ACCESS REPORT

DEVELOPMENT APPLICATION

“SITE 9”

MIXED RETAIL / COMMERCIAL / RESIDENTIAL DEVELOPMENT

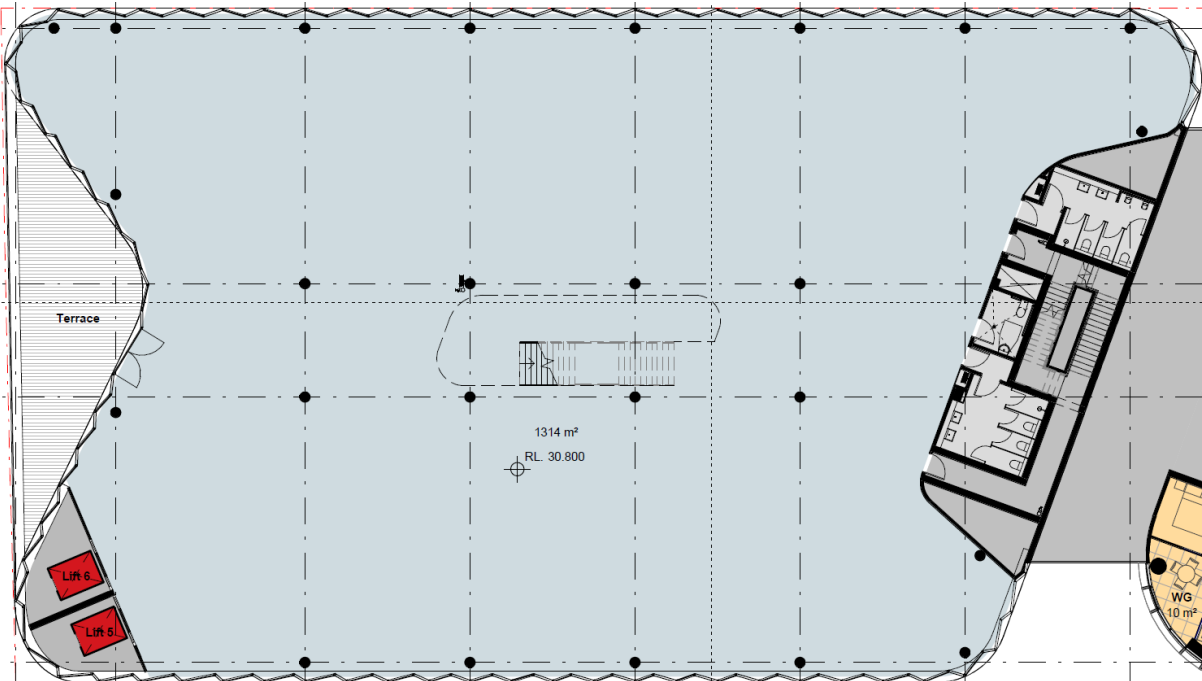
BCA / DDA Access Code Review	Complies
4. Common Residential Entry Lobby – The development proposes a level threshold entrance to the common residential lobby @RL13.00 through an auto sliding doorway which facilitates universal access that complies with AS1428.1 to satisfy D3.2 and Table D3.1 of the BCA and the SOP Access Guidelines.	YES

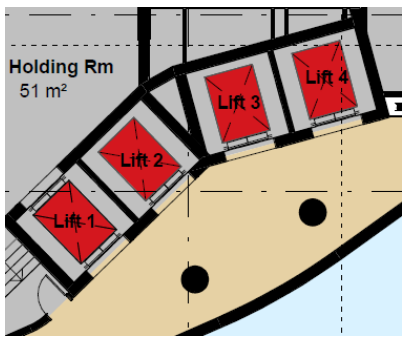
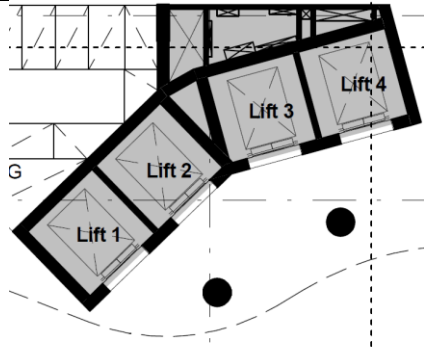
BCA / DDA Access Code Review	Complies
10. The development proposes 49 retail/commercial car spaces with at least 5 accessible parking spaces, which provide 2400mm width adjoining 2400mm width shared areas while the carpark will have 2200mm minimum entry and aisle height clearances on level areas in accordance with AS2890.6 to satisfy Part D3.5 of the BCA, the DDA Premises Standards and the SOP Access Guidelines.	YES
11. Level 2 provides (1) accessible retail space and (1) accessible visitor space with level access to the common lifts which travel to the ground floor retail and the residential apartment levels.	YES
12. Level 3 provides (1) accessible retail space and (2) accessible commercial spaces with level access to the common lifts which travel to the ground floor retail and the residential apartment levels.	YES

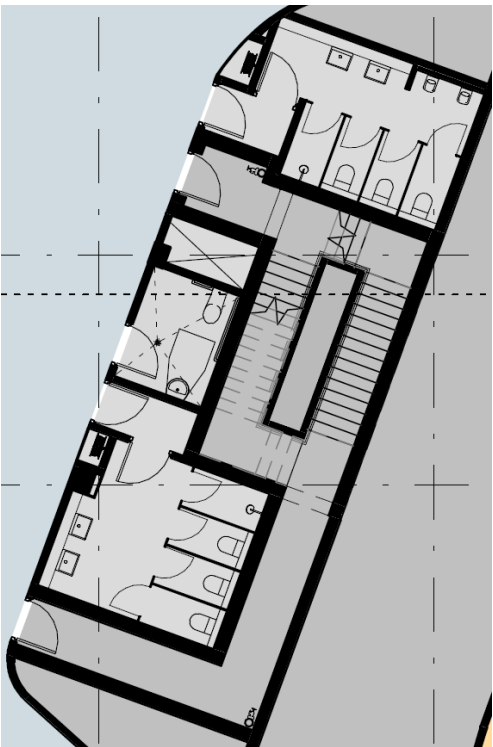
BCA & SOP Access Guideline Review	Complies
<p>30. At the southern end of the lifts the plans propose 1600mm minimum width corridors which facilitate direct access to all apartment entrance doorways and facilitate Turning Areas in accordance with AS1428.1 while the T-junction facilitates Passing Areas to satisfy Part D3.3 of the BCA and the SOP Access Guidelines.</p> <p>31. At Level 09 the plans propose the northern corridor shall continue to a Common Room and the outdoor common area roof terrace via a 1600mm minimum width corridor which facilitates level access and complying doorway circulation spaces to ensure equitable access in accordance with AS1428.1 to satisfy Part D3.3 of the BCA and the SOP Access Guidelines.</p> 	<p>YES</p> <p>YES</p>
<p>32. Level 9 Common Room – The level 9 Common Room design confirms doorway and internal circulation spaces to and within complying with AS1428.1 to satisfy Part D3.3 and Table D3.1 of the BCA and the SOP Access Guidelines.</p>	<p>YES</p>

1 4B-A (Pre Adaption) 1:100

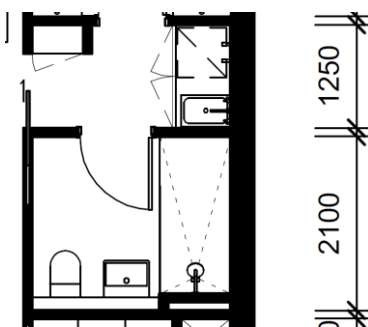
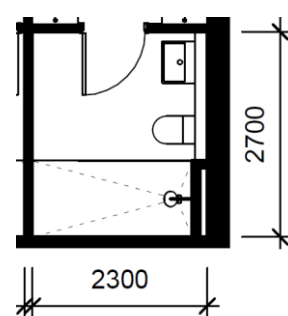
AS4299 Clause 4.7	Bathroom – The plans show that the bathrooms will be at least 2700mm X 2400mm, which enables compliance with AS1428 in terms of spatial area.	YES
	To facilitate adaptation to an accessible unit the toilet pan, washbasin and shower shall require some adjustment of the pre-adaptation locations to satisfy the performance requirements of AS4299.
